E5070B-06E

S E R V I C E N O T E

E5070B ENA Series Network Analyzer, 300 kHz to 3 GHz

Change the RF signal path configuration and update firmware to 5.02 or later to improve the input damage level tolerance

**Figure 1 Front View (Semi-rigid Cables Opt. 213 before modification)**

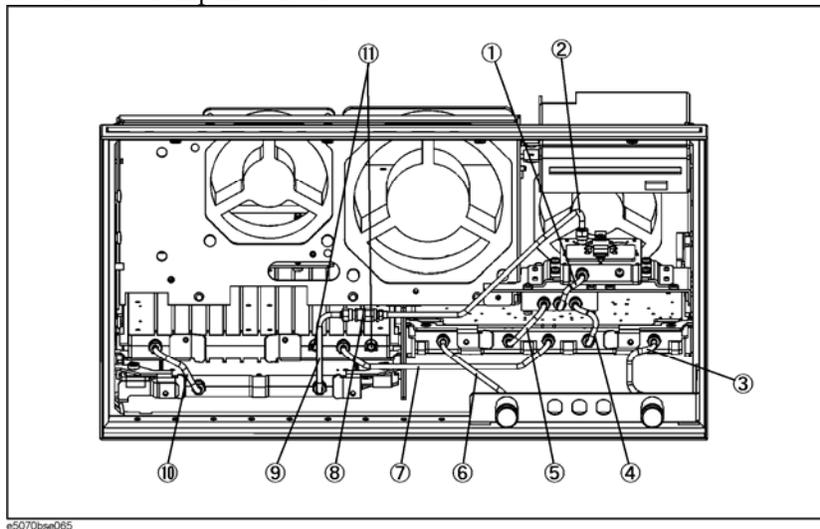
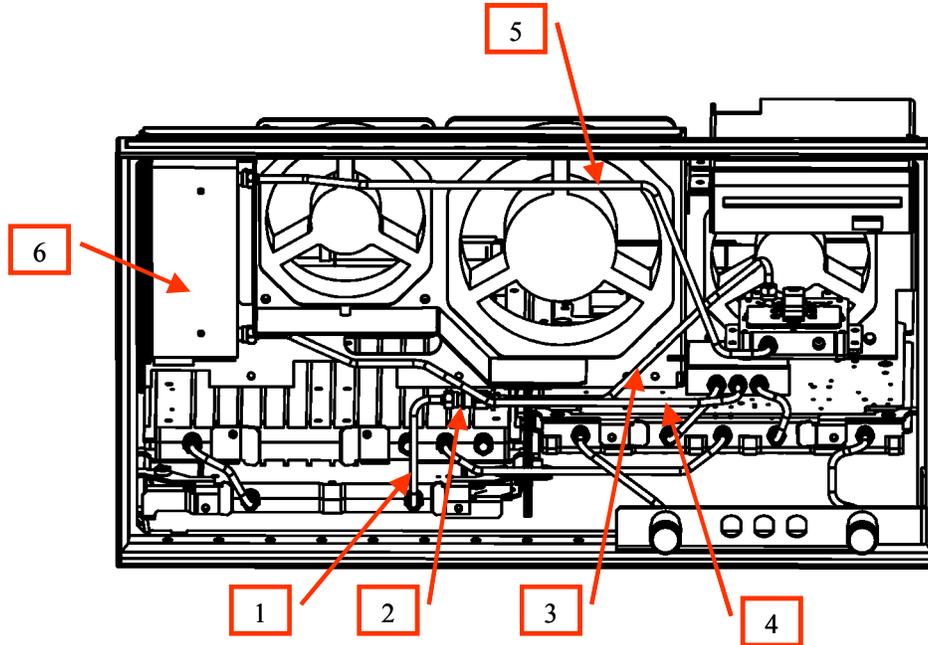
1. Remove outer cover. *1
2. Remove front panel. *1
3. Remove A28 Floppy Disk Drive (FDD) unit. *1
4. Remove semi-rigid cables in figure 1 No. 1 (E5070-61685) and No. 2 (E5070-61672)
5. Remove defective A4 Power amp module *1

8. Install new A4 power amp module to an original place.
9. Connect uW attenuator 0955-0208 (No 2 in Figure4) and A4 with E5070-61672 semi-rigid cable (No 3 in Figure 4)
10. Connect A4 and A7 ATT with E5070-61633 semi-rigid cable (No 5 in Figure 4)
11. Connect A7 ATT and A8 with E5070-61634 semi-rigid cable (No 4 in Figure 4)

**Figure 4 Front View (Semirigid Cables Opt. 213, 214 after modification)**

Figure 2 Make A7 attenuator assembly (for option 213)

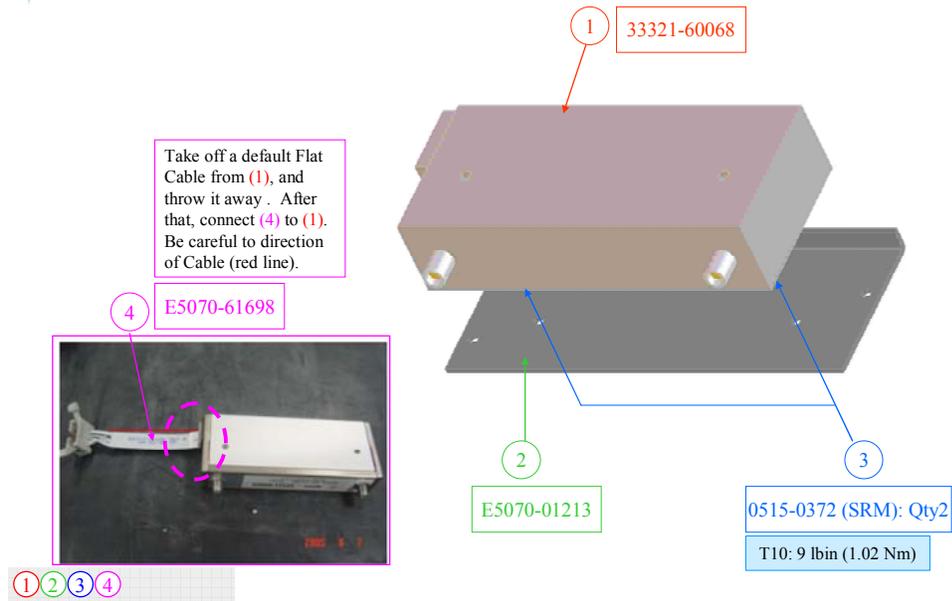
- Make A7 step attenuator assembly by 33321-60068 (1ea), E5070-61698 (1ea), E5070-01213 (1ea), 0515-0372 (2ea) and E5070-61617 (1ea). E5070-61698 is the cable between 33321-60068 and E5070-61617.

Figure 3 Install A7 attenuator assembly (for option 213)

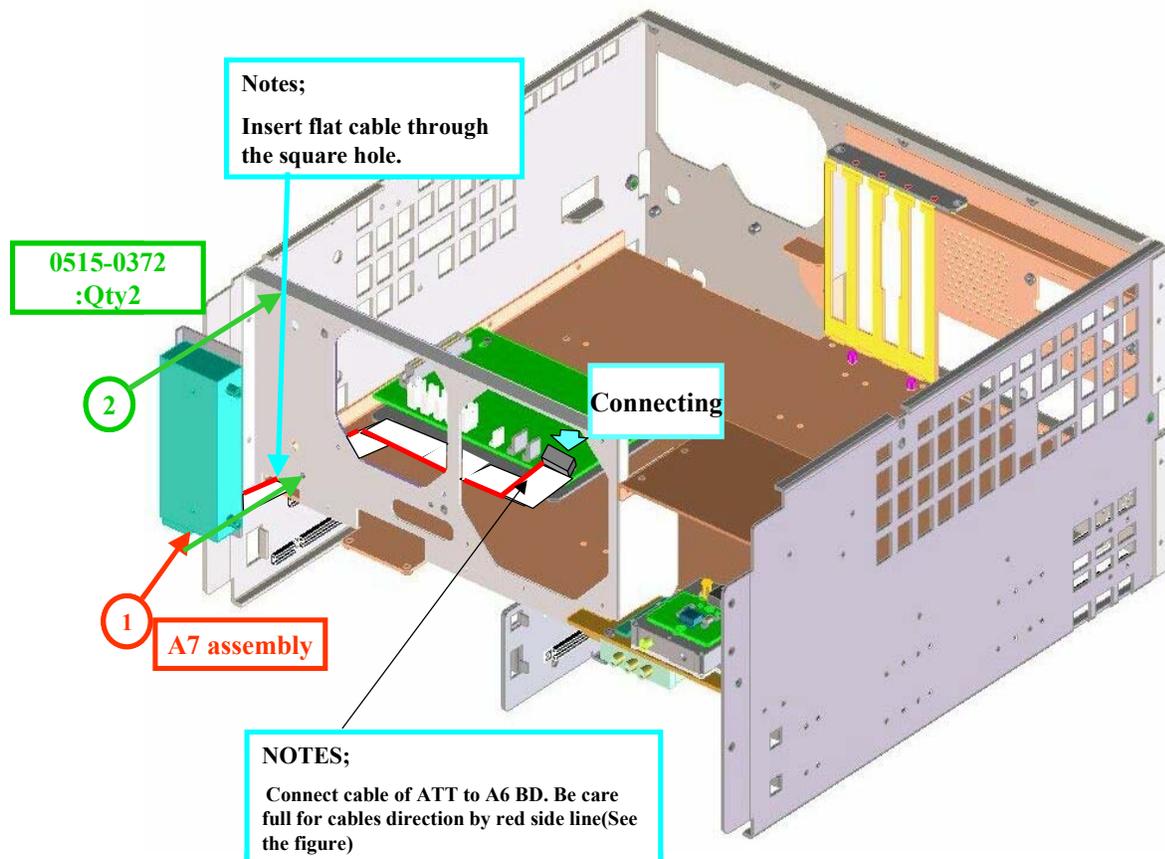
- Install A7 assembly with 0515-0372 2 ea. Be careful to flat cable direction and its connectivity.

Figure 5 Front View (Miscellaneous Parts)

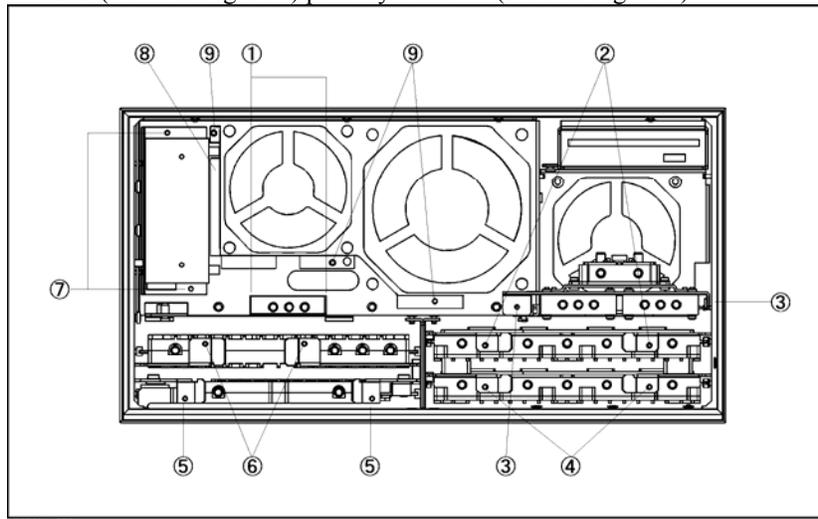
1. Remove outer cover. *1
 2. Remove front panel. *1
 3. Remove A28 Floppy Disk Drive (FDD) unit. *1
 4. Remove E5070-01222 (No. 8 in Figure 5) plate by 3 screws (No.9 in Figure 5)
- *1: Refer to E5070B/E5071B Service manual chapter 6 for details

Figure 6 Front View (Semirigid Cables Opt. 214 before modification)

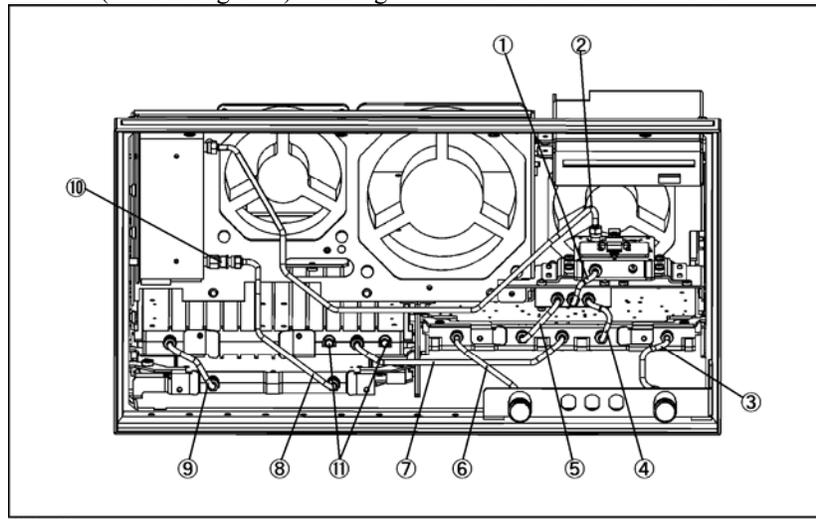
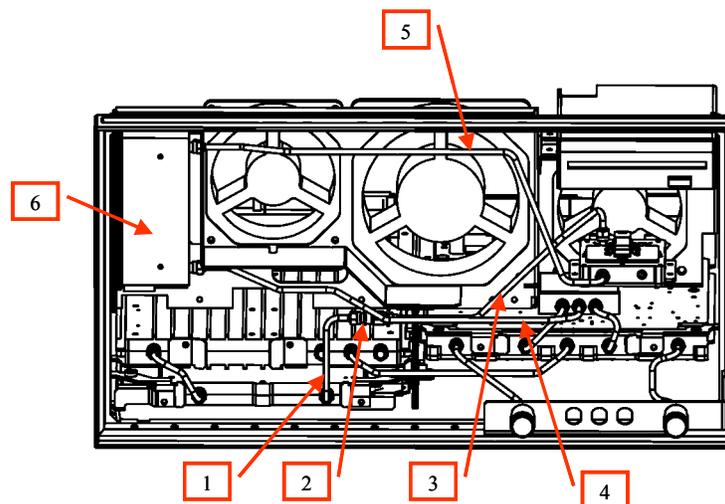
5. Remove E5070-61673 (No. 8 in Figure 6) semi-rigid cable from A3 and 0955-0208 (No 10 in Figure 6) attenuator
6. Remove 0955-0208 (No 10 in Figure 6) attenuator from A7 ATT module
7. Remove E5070-61674 (No 2 in Figure 6) semi-rigid cable from ATT and A4 amp
8. Remove E5070-61685 (No 1 in Figure 6) semi-rigid cable from A4 and A8 switch.

9. Remove defective A4 Power amp module *1
10. Remove A7 attenuator module by 2 screws.
11. Make new A7 attenuator module by 33321-60068 (1ea), E5070-61698 (1ea), E5070-61617 (1ea), 0515-0372 (2ea) and E5070-01213 (1ea). Scrap 33321-60059.
12. Install new A7 attenuator with 0515-0372 (2ea).
13. Install new A4 power amp module to an original place.
14. Connect A3 and 0955-0208 (No 2 in Figure 4, see below) attenuator with E5070-61671 (No 1 in Figure 4) semi-rigid cable
15. Connect 0955-0208 (No 2 in Figure 4) and A4 with E5070-61672 (No 3 in figure 4) semi-rigid cable
16. Connect A4 and ATT with E5070-61633 (No 5 in Figure 4) semi-rigid cable
17. Connect ATT and A8 with E5070-61634 (No 4 in Figure 4) semi-rigid cable
18. Screw E5070-01222 plate to the original place.
19. Set FDD unit.
20. Set front panel
21. Set outer cover

Copy of Figure 4 in page 5

Figure 7 Front View (Semi-rigid Cables Opt. 313 before modification)

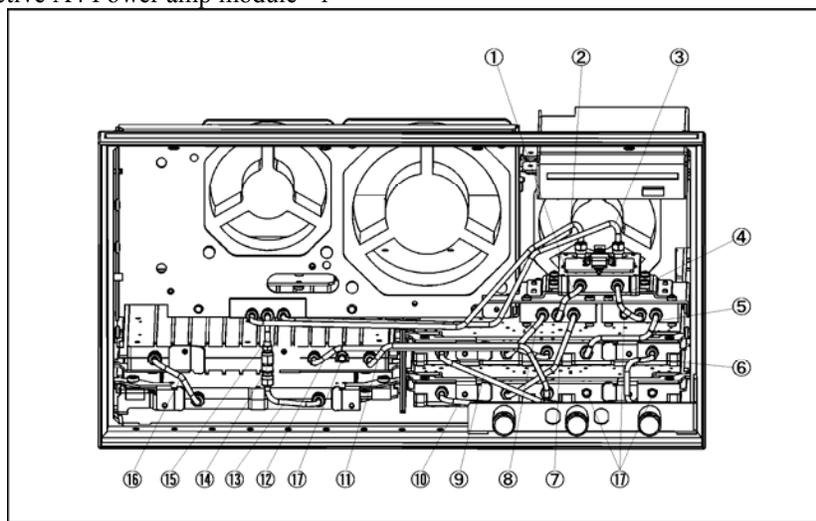
1. Remove outer cover. *1
2. Remove front panel. *1
3. Remove A28 Floppy Disk Drive (FDD) unit. *1
4. Remove E5070-01222 (No. 8 in Figure 5) plate by 3 screws (No.9 in Figure 5)
5. Remove E5070-61685 (No 1 and No 4 in Figure 7) semi-rigid cables from A4 and A8 (receiver side)
6. Remove E5070-61677 (No 2 in Figure 7) and E5070-61678 (No 3 in Figure 7) semi-rigid cables from A4 and A8 (source side)
7. Remove defective A4 Power amp module *1

Figure 8 Make A7 attenuator assembly (for option 313, 314, 413, 414)

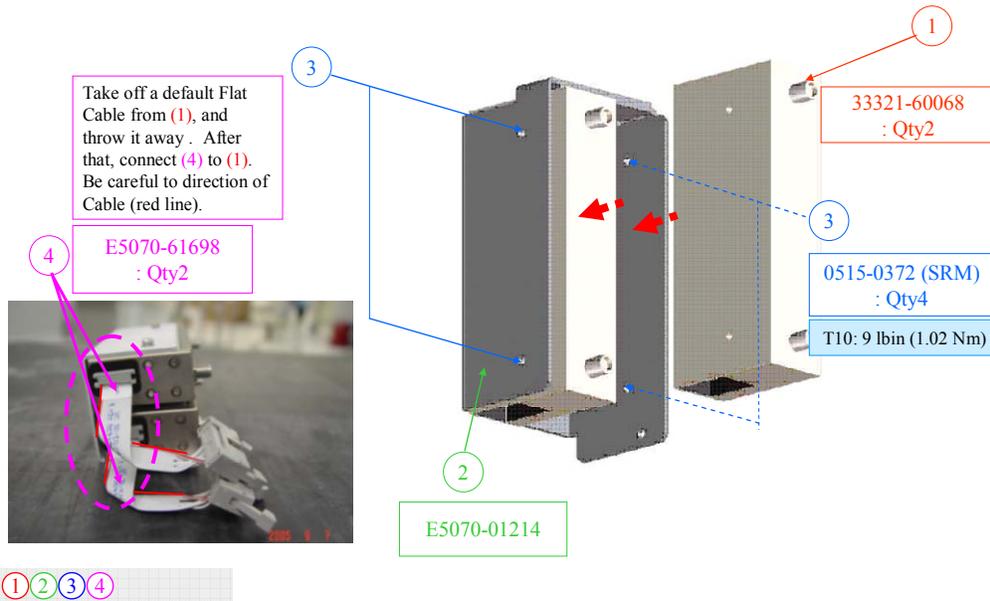
- Make A7 step attenuator assembly by 33321-60068 (2ea), E5070-61698 (2ea), E5070-01214 (1ea), 0515-0372 (4ea) and E5070-61618 (1ea). 2ea of E5070-61698 is the cable between 33321-60068 and E5070-61618.

Figure 9 Install A7 attenuator assembly (for option 313, 314, 413, 414)

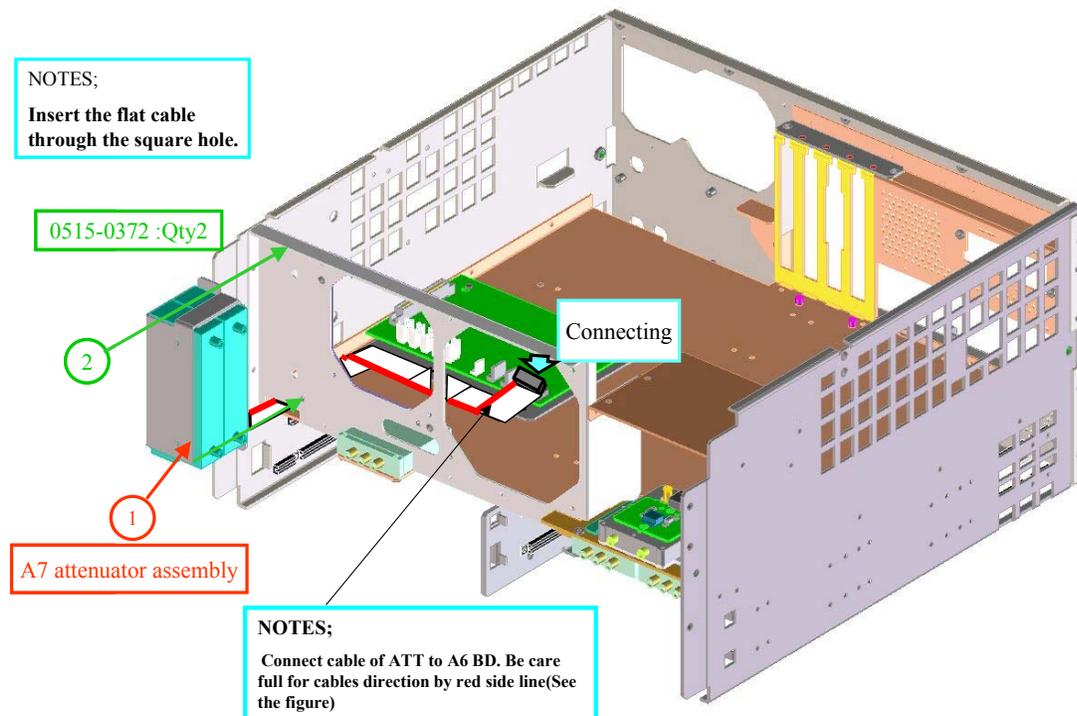
- Install A7 assembly with 0515-0372 2 ea. Be careful to the flat cable's direction and connection.

Figure 10 Front View (Semirigid Cables Opt. 313, 314 after modification)

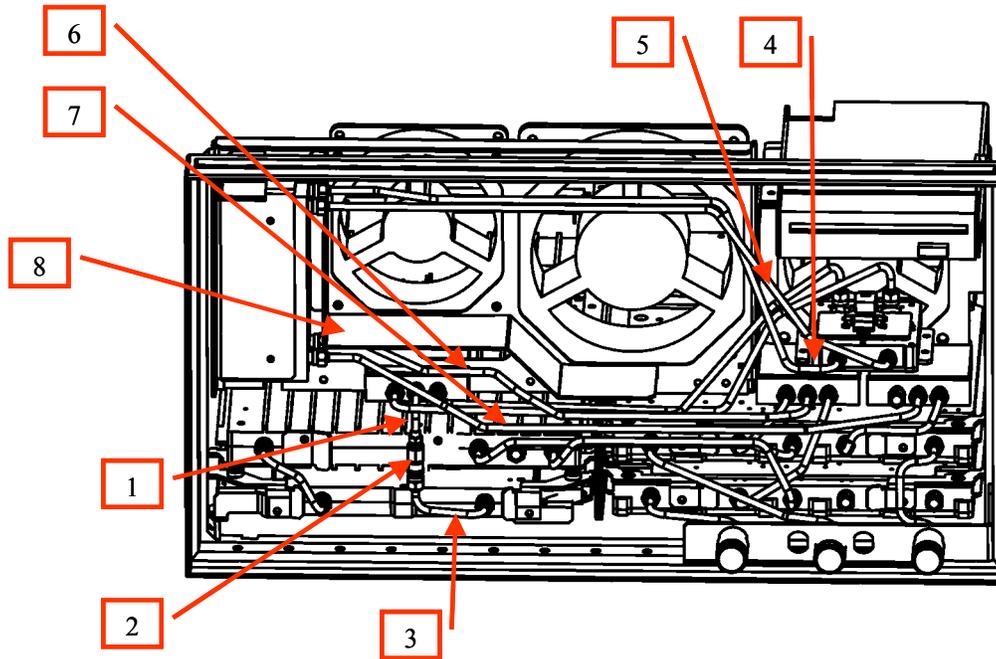
10. Install new A4 power amp module to an original place.
11. Connect A8 (source side) and A4 with E5070-61677 and E5070-61678 that is removed in step 6.
12. Connect A4 and A7 ATT with E5070-61633 (No 4 in Figure10) semi-rigid cable
13. Connect A4 and A7 ATT with E5070-61635 (No 5 in Figure 10) semi-rigid cable
14. Connect ATT and A8 with E5070-61634 (No 6 in Figure 10) semi-rigid cable
15. Connect ATT and A8 with E5070-61636 (No 7 in Figure 10) semi-rigid cable

16. Screw E5070-01223 plate (No 8 in figure 10) instead of E5070-01222
17. To avoid the friction between new semi-rigid cables and front panel's cable clamp, remove two 1400-0611, cable clamp, from original place, then stick two new 1400-0611, cable clamp, as shown in Figure 11 lower. Then change a bending position of LCD flat cable (white one) according to Figure 11 upper.

Figure 12 Front View (Semirigid Cables Opt. 314 before modification)

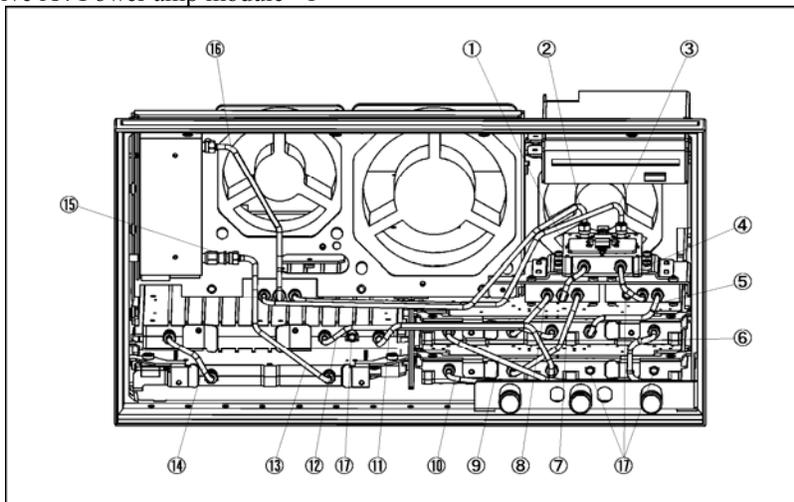
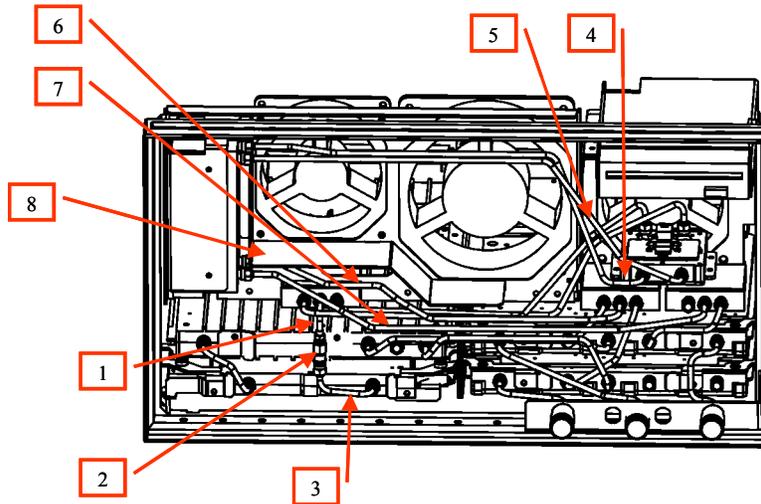
1. Remove outer cover. *1
2. Remove front panel. *1
3. Remove A28 Floppy Disk Drive (FDD) unit. *1
4. Remove E5070-01222 (No. 8 in Figure 5) plate by 3 screws (No.9 in Figure 5)
5. Remove E5070-61685 (No 1 and No 4 in Figure 12) semi-rigid cables from A4 and A8 (receiver side)
6. Remove E5070-61677 (No 2 in Figure 12) and E5070-61678 (No 3 in Figure 12) from A4 and A8 (source side)
7. Remove E5070-61673 (No 13 in Figure 12) semi-rigid cable from A3 and 0955-0301 (No 15 in Figure 12).
8. Remove 0955-0301 (No 15 in Figure 12) uW attenuator from A7 ATT
9. Remove E5070-61656 (No 16 in Figure 12) semi-rigid cable from A7 and A8
10. Remove defective A4 Power amp module *1

11. Remove A7 attenuator module by 2 screws (No. 7 in Figure 5).
12. Make new A7 attenuator module by 33321-60068 (2ea), E5070-61698 (2ea), E5070-61618 (1ea), 0515-0372 (2ea) and E5070-01214 (1ea). Scrap 33321-60059, E5070-01213 and E5070-61617. Refer to Figure 8 for the detail.

13. Install new A7 attenuator with 0515-0372 2 ea. Refer to Figure 9 for the detail.
14. Install new A4 power amp module to an original place
15. Connect A3 and 0955-0301 (removed in step 8) with E5070-61675 (No 3 in Figure 10, see below) semi-rigid cable

16. Connect 0955-0301 and A8 (source side) with E5070-61676 (No 1 in Figure 10)
17. Connect A8 (source side) and A4 with E5070-61677 and E5070-61678 that are removed in step 6

18. Connect A4 and A7 ATT with E5070-61633 (No 4 in Figure 10) semi-rigid cable
19. Connect A4 and A7 ATT with E5070-61635 (No 5 in Figure 10) semi-rigid cable

20. Connect ATT and A8 with E5070-61634 (No 6 in Figure 10) semi-rigid cable
21. Connect ATT and A8 with E5070-61636 (No 7 in Figure 10) semi-rigid cable

22. Screw E5070-01223 plate (No 8 in figure 10) instead of E5070-01222
23. To avoid the friction between new semi-rigid cables and front panel's cable clamp, remove two 1400-0611, cable clamp, from original place, then stick two new 1400-0611, cable clamp, as shown in Figure 11 lower. Then change a bending position of LCD flat cable (white one) according to Figure 11 upper

Copy of Figure 10 in page 11

Figure 13 Front View (Semirigid Cables Opt. 413 before modification)

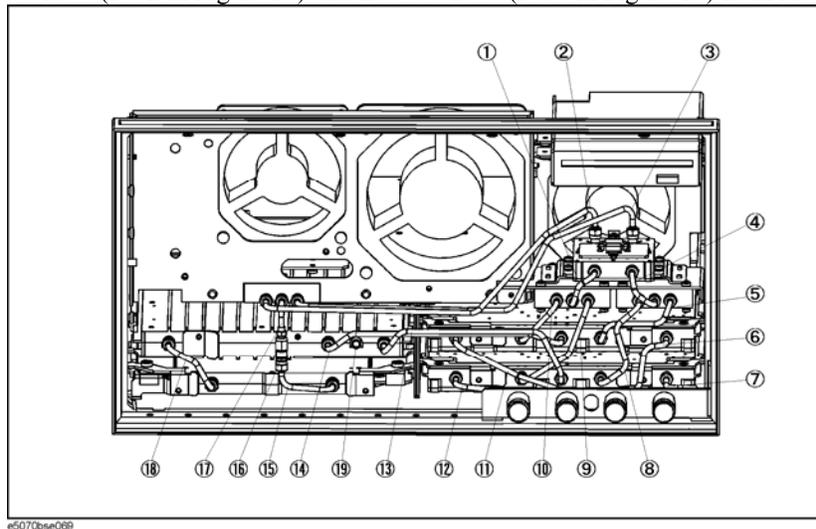
1. Remove outer cover. *1
2. Remove front panel. *1
3. Remove A28 Floppy Disk Drive (FDD) unit. *1
4. Remove E5070-01222 (No. 8 in Figure 5) plate by 3 screws (No.9 in Figure 5)
5. Remove E5070-61685 (No 1 and No 4 in Figure 13) semi-rigid cables from A4 and A8 (receiver side)
6. Remove E5070-61677 (No 2 in Figure 13) and E5070-61678 (No 3 in Figure 13) from A4 and A8 (source side)

Figure 14 Front View (Semirigid Cables Opt. 413, 414 after modification)

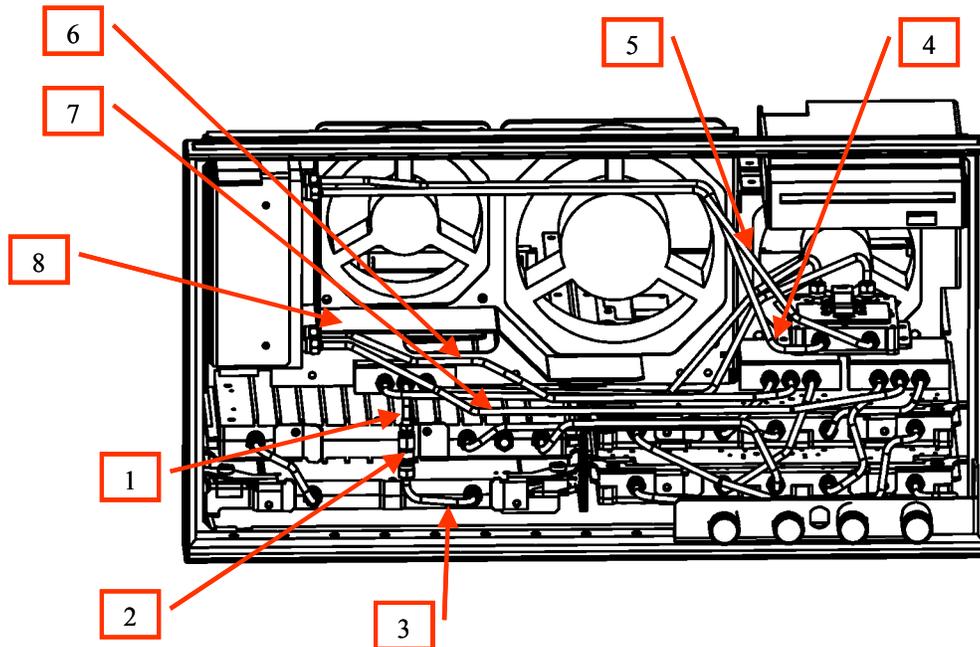
8. Make A7 step attenuator assembly by 33321-60068 (2ea), E5070-61698 (2ea), E5070-01214 (1ea), 0515-0372 (4ea), and E5070-61618 (1ea). Refer to Figure 8 for the detail.
9. Install A7 assembly with 0515-0372 2 ea. Be careful to the flat cable's direction and connection. Refer to Figure 9 for the detail.
10. Install new A4 power amp module to an original place
11. Connect A8 (source side) and A4 with E5070-61677 and E5070-61678 that are removed in step 6
12. Connect A4 and A7 ATT with E5070-61633 (No 4 in Figure14) semi-rigid cable
13. Connect A4 and A7 ATT with E5070-61635 (No 5 in Figure 14) semi-rigid cable
14. Connect ATT and A8 with E5070-61634 (No 6 in Figure 14) semi-rigid cable
15. Connect ATT and A8 with E5070-61636 (No 7 in Figure 14) semi-rigid cable
16. Screw E5070-01223 plate (No 8 in figure 14) instead of E5070-01222

17. To avoid the friction between new semi-rigid cables and front panel's cable clamp, remove two 1400-0611, cable clamp, from original place, then stick two new 1400-0611, cable clamp, as shown in Figure 11 lower. Then change a bending position of LCD flat cable (white one) according to Figure 11 upper
18. Set FDD unit.
19. Set front panel. Be careful not to jam cables between front panel and front frame
20. Set outer cover.
21. Remove "option 413" label from back panel, and stick 5185-3718, "option 414" label instead of it.
